Official Transcript of Proceedings
NUCLEAR REGULATORY COMMISSION

Title: ACRS AP1000 Subcommittee

Date: November 17, 2010

UNITED STATES OF AMERICA
NUCLEAR REGULATORY COMMISSION
+ + + + +
ADVISORY COMMITTEE ON REACTOR SAFEGUARDS
(ACRS)
AP1000 REACTOR SUBCOMMITTEE MEETING

Shield Building Design Features

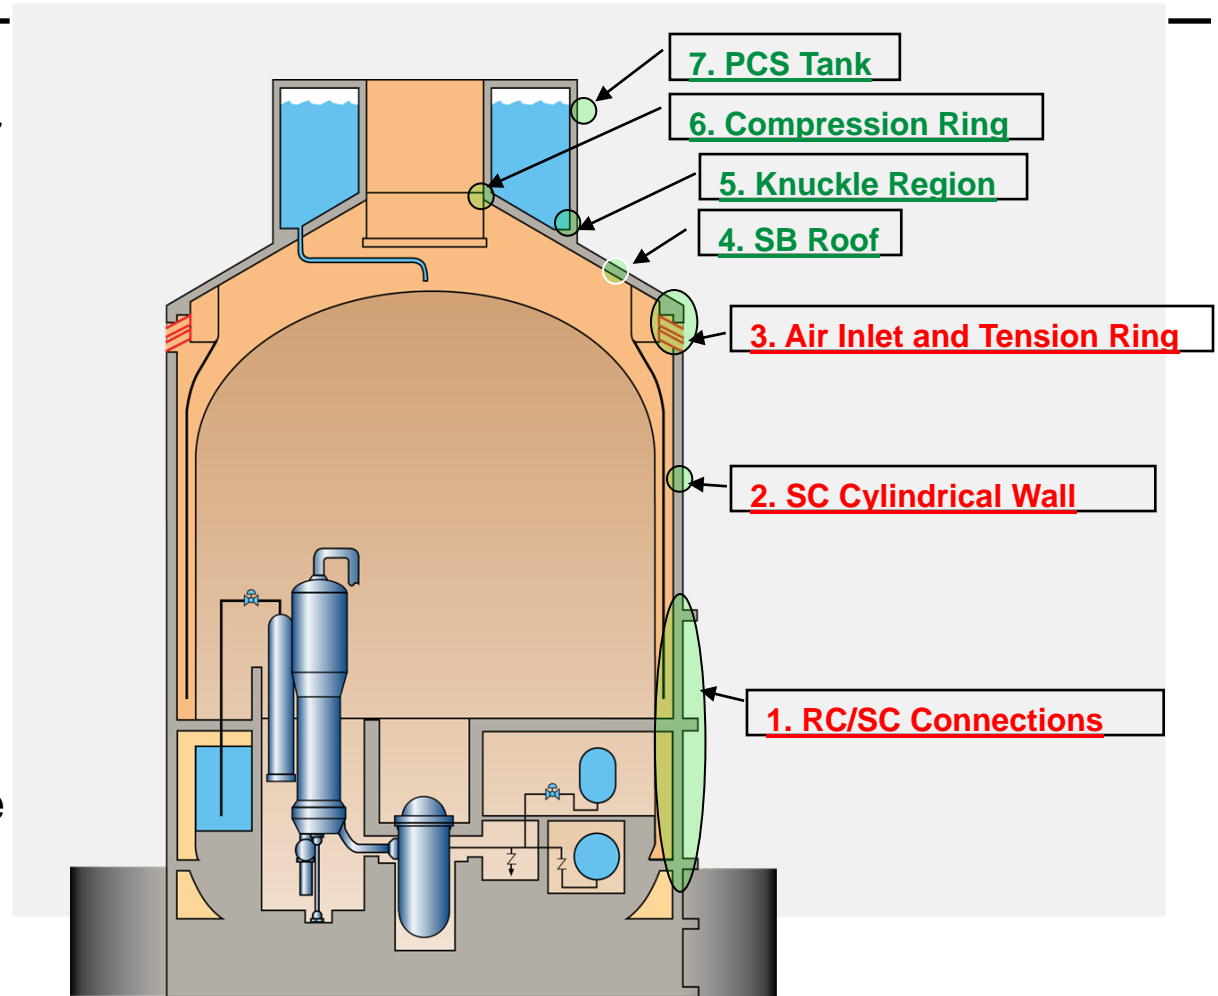
- Revised the air inlet/ tension ring design for constructability and strength
- Reinforced cylindrical wall with tie bars between steel plates
- Increased SC plate thickness to improve strength and ductility
- RC/SC connection redesigned to improve ductility

CSDR High Frequency Exceedance (continued)

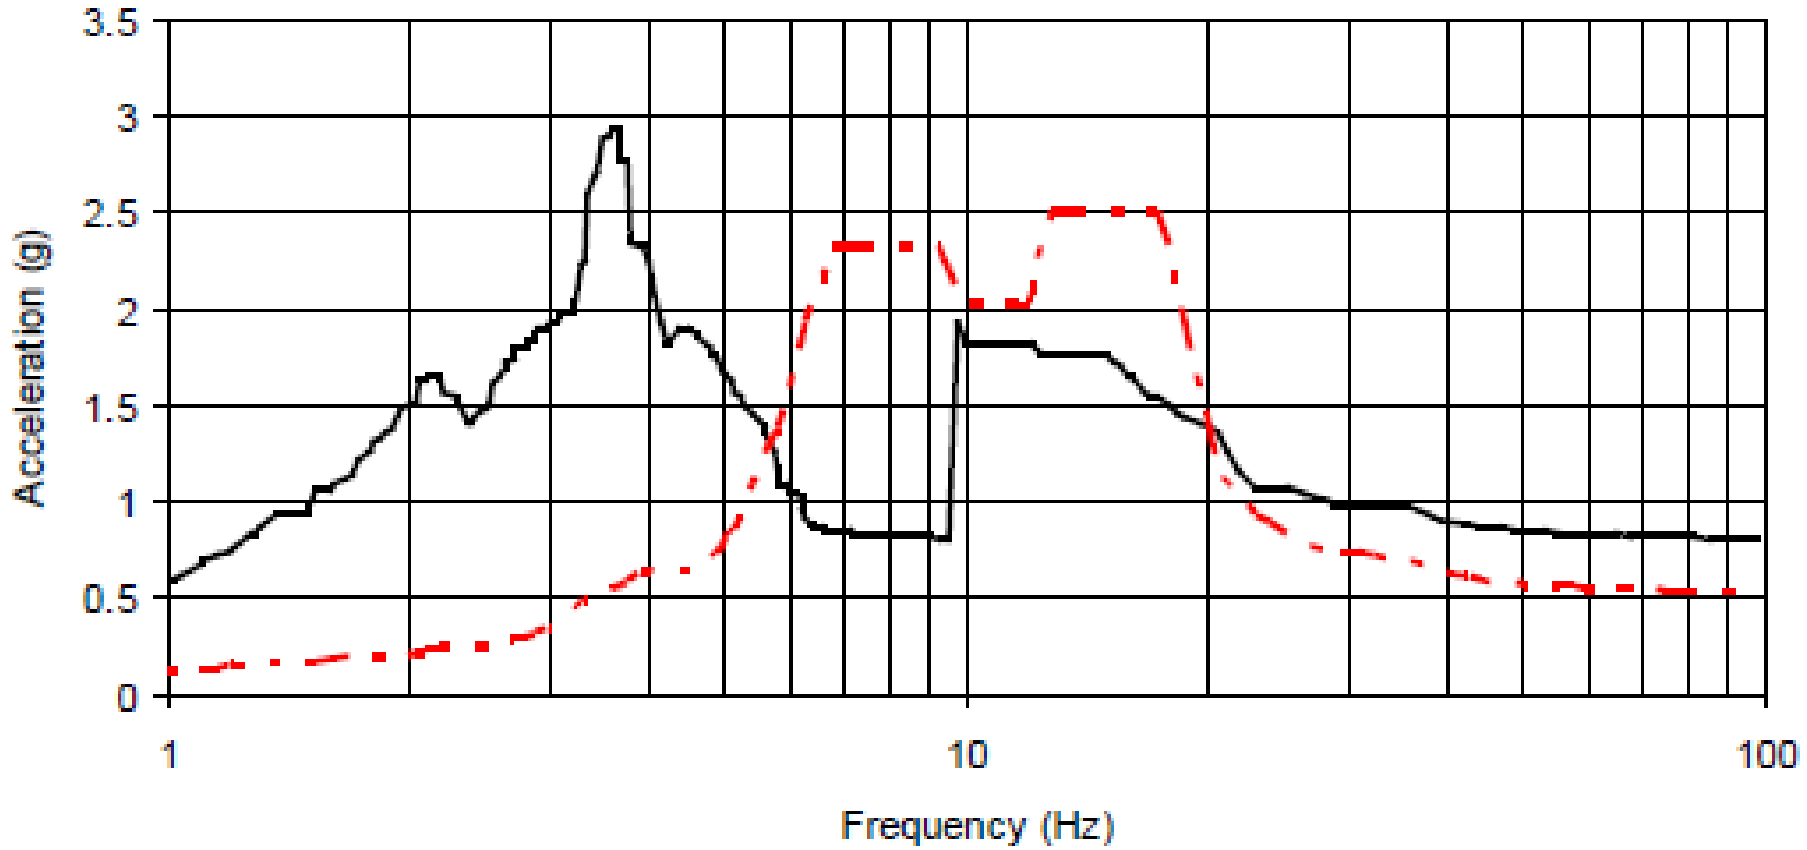
In the evaluation of SSCs other than HF sensitive equipment, for those cases where the GMRS-based ISRS exceed the CSDRS-based ISRS below 50 Hz, further structural integrity and functionality evaluations are required.

- **Path to Resolution**
